**Re: Development Application No. DA2022/1000 ('the DA') at
14-22 Wentworth Street & 19-21 South Steyne, Manly ('the Property')**

We write on behalf of our Client, Royal Far West ('RFW') and further to the Northern Beaches Council's project correspondence dated 16 September 2022. Our consideration of issues raised in this letter is provided below.

1. Design Sustainability Advisory Panel ('DSAP') Comments.

Figure 1: Sectional diagram examining the western façade bay window's partial encroachment.

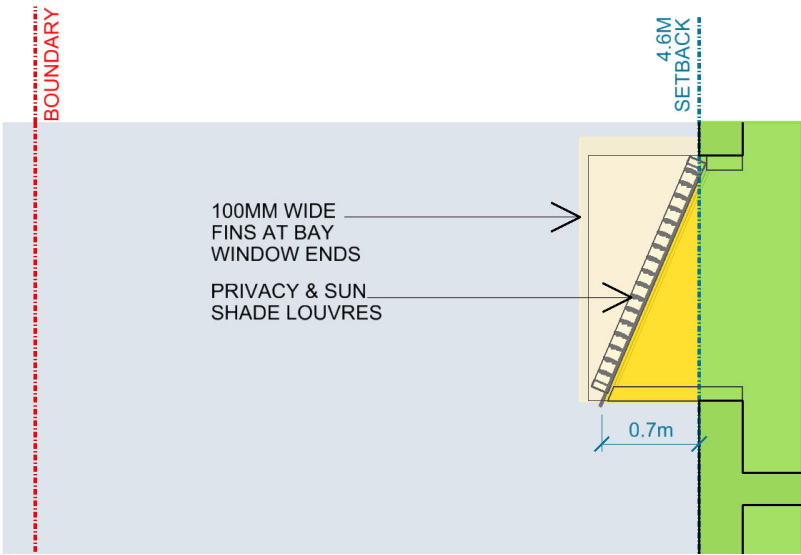
- f. Building C's upper-level residential western façade (occurring above No. 29 Victoria Parade) includes a number of triangular profiled bay windows which partially are less than 4.6m from this side property boundary. These windows include integrated sun shading and privacy louvres as part of their design. This triangular, repeating window element provides an important amount of façade enrichment due to its human scaled proportions, detailed modular construction and the resulting rhythmic play of light and shadow across the façade. This is done without large bulk or impeding access to light and air to the neighbouring properties. This façade design is considered superior to that of a more flat façade meeting the 4.6m set back control. The design of these bay windows is such that they will address unwanted visual privacy concerns onto neighbours by way of their horizontal blade profiled shape resulting in a positive outcome for the neighbours.

- h. It is a commonly accepted town planning concept to consider minor encroachments into a setback control as acceptable provided there are positive benefits to all parties and that any negative impacts are acceptable. The proposal's bay window elements positively contribute to both the neighbour and the proposed development by enlivening the façade with shadow and relief as well as containing simple and robust visual privacy treatments. Due to the overall project masterplan design and its enshrined building forms, strict compliance to this side setback control would likely only serve to flatten the façade relief and reduce the performance of any privacy device resulting in a poorer outcome for the neighbours (and residents of the project).

Figure 2: Sectional diagram examining the side setback condition to No. 29 Victoria Pde Manly.

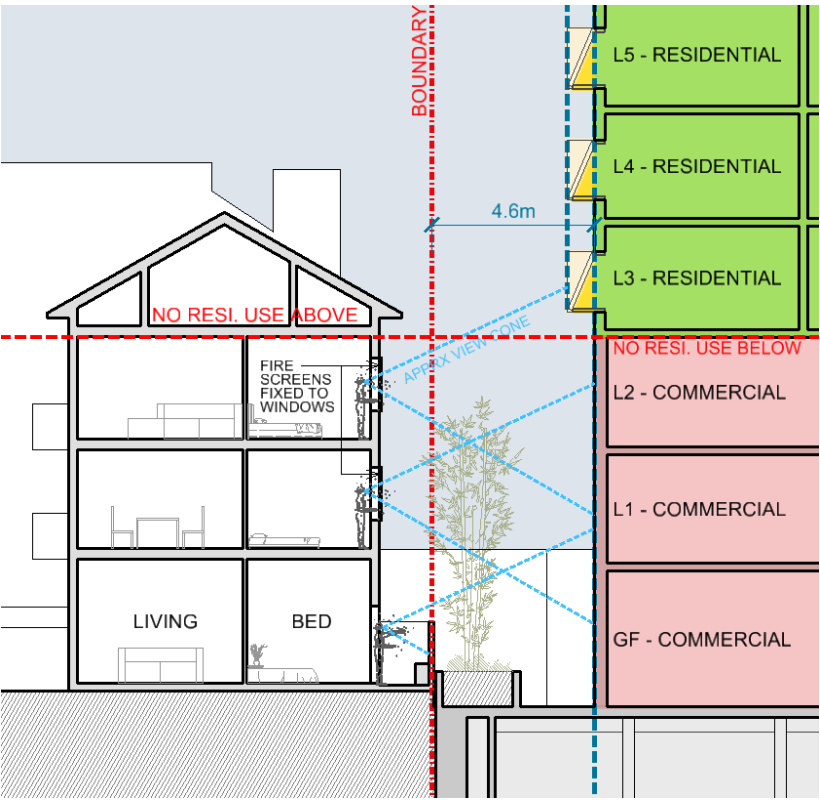
- a. The proposed external building walls of the development (all levels) are set back an amount equal to or greater than 4.6m from the side property boundary (as noted in the Concept Approval).

- b. The external walls for the levels opposite No. 29 Victoria Parade (Levels Ground, 1 & 2) include a greater than 4.6m setback to ensure that the façade privacy screening elements are also outside of this 4.6m set back zone.

Figure 3: Floor plan overlay diagram showing the existing building footprint at No 19-21 South Steyne (in red) overlaid with the proposed DA residential level floor plan (level 3).

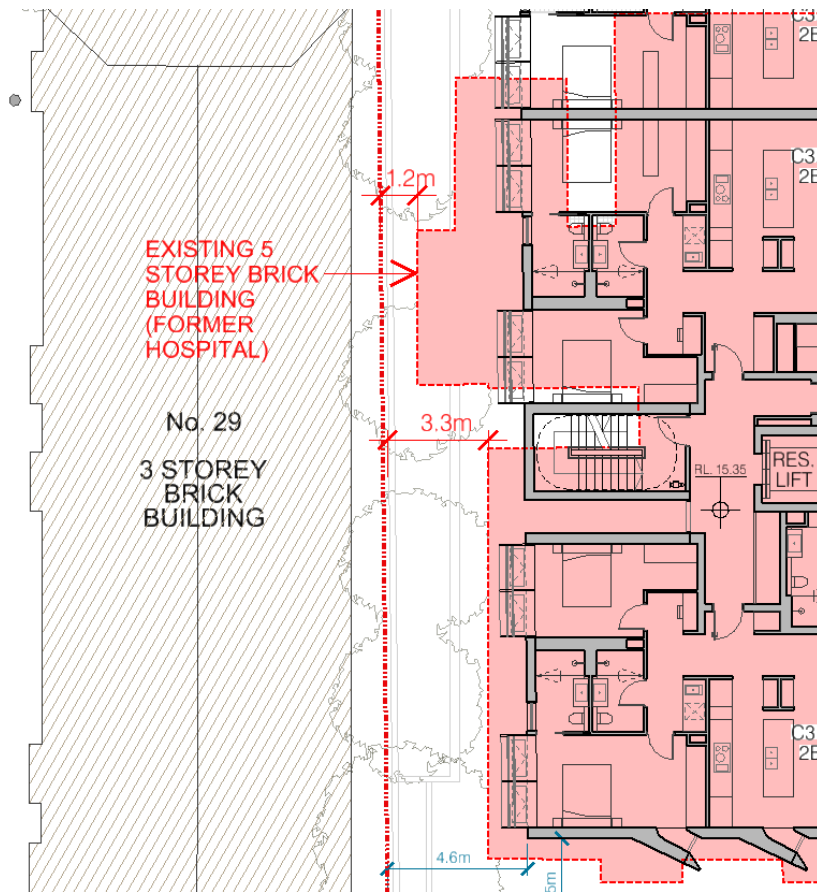
- e. The footprint of the existing 5 storey brick (former polio hospital) building (No.19-21 South Steyne) on the Property is significantly closer to No. 29 Victoria Parade than the proposed DA design. The proposed DA design will be a significant improvement on the existing condition due to its increased setbacks, privacy screening, landscape buffer planting, and a more articulated and varied building façade.

Figure 6: Overlay diagram of the S75W Concept envelopes with the proposed detailed DA design (NW corner of Building D).

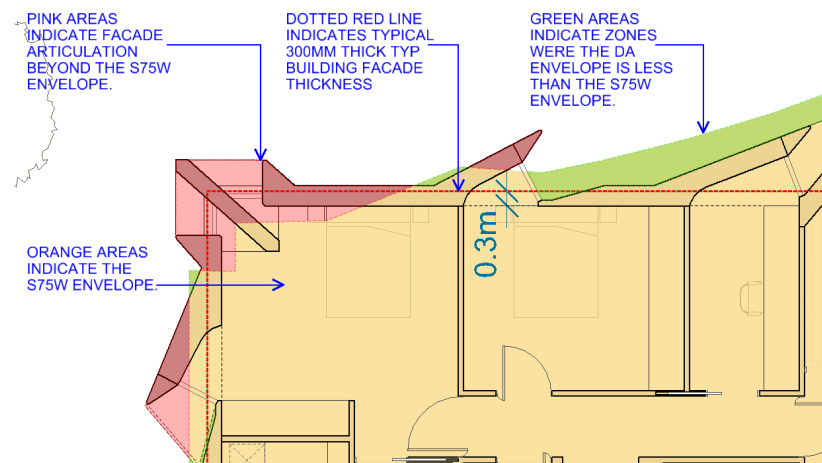
There are some minor differences between this detailed development application and the Concept Approval around the North-western corner of Building D. These differences are a result of subsequent more detailed consideration of both the spaces within the building along with the overall architectural forms and their reading from the public domain. The project is seeking to achieve a high degree of façade articulation with a rich and varied arrangement of architectural elements such as fins, ledges, voids and the like. These elements have a significant façade depth associated with them when compared with a more typical apartment building façade thickness (say 300mm for a typical wall thickness). As a result, there are some instances where the proposed DA façade alignment deviates from the Concept Plan envelope. It is our opinion that these deep façade articulations add significantly to the appreciation of the building when viewed from the public domain and are a superior result when to more traditional flatter facades. These relatively minor differences to the Concept envelopes do not impact view corridors through the development from public or private areas. It is our opinion that these differences are not inconsistent with the Concept Approval and contribute positively to the appreciation of the building from the public domain.

Figure 7: View from the Sun diagram (9.20am 21 June) extract from Sheet DA-150 Shadow Analysis Sheet 6. The orange colour denotes solar access into apartment living areas.

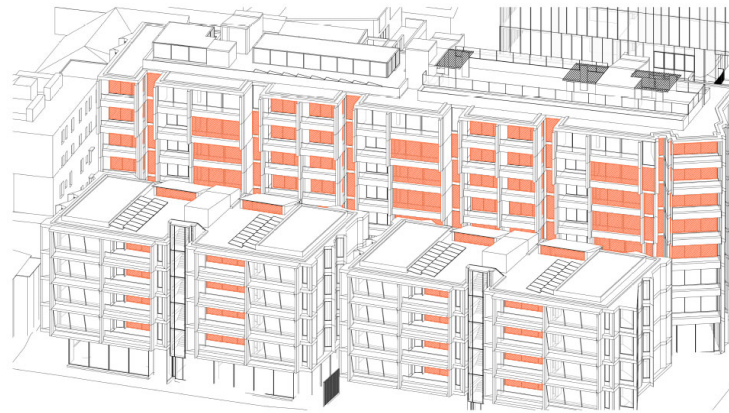
The accompanying 'Issue 02' architectural DA drawings include a detailed consideration of solar access into living areas for both Buildings C & D. This analysis includes 'Views from the Sun' studies at relevant time increments (mid-winter). Given the amendments to the apartment living areas in Building C (along with their easterly orientation), solar access into these larger living rooms in Building C is significantly improved compared with the earlier DA. 79.3% of apartments receiving compliant solar access, well exceeding the requirements noted in the Apartment Design Guide ('ADG').

Figure 8: Diagram of issues associated with ceiling air conditioning units built into kitchen joinery.

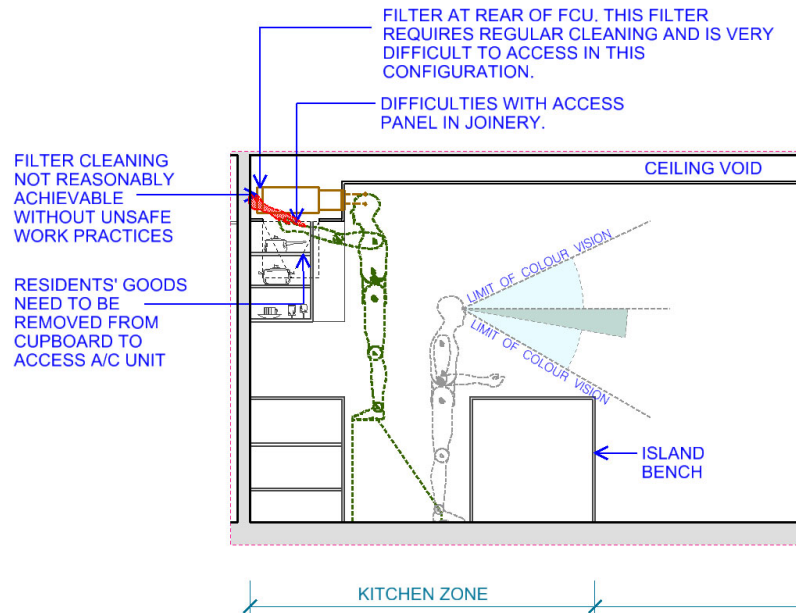
It is proposed to lower (for a portion) the kitchen ceiling height to 2.4m above floor level (from 2.7m). This will enable the installation of an apartment air conditioning unit into a freely accessible area (for equipment maintenance) and will not block light and ventilation from the façade openings. As longer-term maintenance issues arise, designers are becoming more aware that earlier approaches to design joinery mounted air conditioning fan coil units (FCUs) are no longer acceptable both in terms of a manufacturers' warranty standpoint as well as due to OHSR access requirements. We understand that surrounding these units with fixed elements such as kitchen cupboards and the like prevents the necessary and regular cleaning regimes of these units and is likely to lead to poor outcomes for the apartment resident (decreased performance, higher energy consumption and costs as well as possible future partial removal of built-in kitchen elements and their contents for improved access to these FCUs).

The proposed 2.4m high kitchen ceiling zones included in this application occur mostly over joinery elements such as island benches and cupboards (i.e. non-trafficable portions of the kitchen) and is only proposed for the more internalised spaces within an apartment (i.e. not adjacent to windows which may impact access to light and ventilation). Further these areas allow ready access to the FCU for maintenance allowing for limited inconvenience to the apartment resident. It is our opinion that these proposed lowered ceiling zones (in apartment kitchens only) meet the Objective 4C-1 of the Apartment Design Guide and allow for a superior outcome with respect to the continued long-term heating and cooling systems provided to these apartments.
